Product Bulletin:

December 16, 2020

Subject: Plate Trailers - Sidewall Panel Consolidation

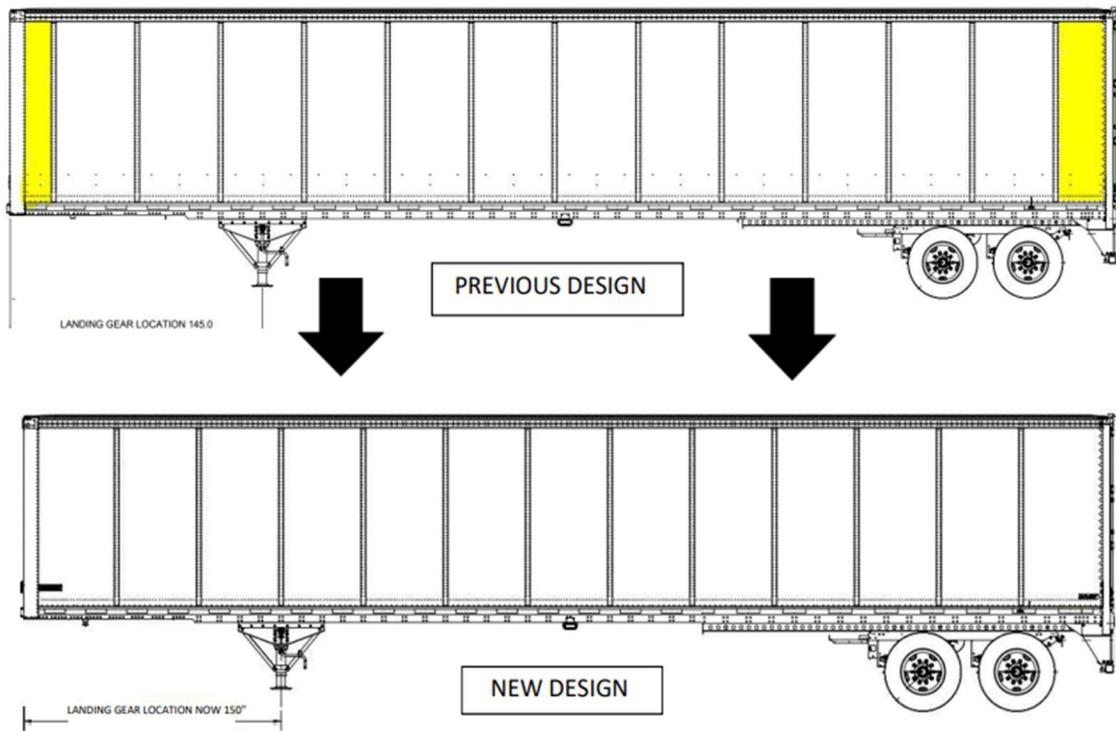
Stoughton Trailers has recently implemented a change to all plate van trailers. Going forward, all plate van trailers will be built having uniform 48" wide panels running the entire length of the trailer. There will no longer be unique panels (commonly referred to as "starters and finishers") for the first and last panels on each sidewall. This running change will reduce the number of repair parts required as all sidewall panels will now be the same. Having uniform side panels creates a cleaner look and eliminates one splice plate per sidewall. Please note the landing gear is now located 5" further back from the nose.
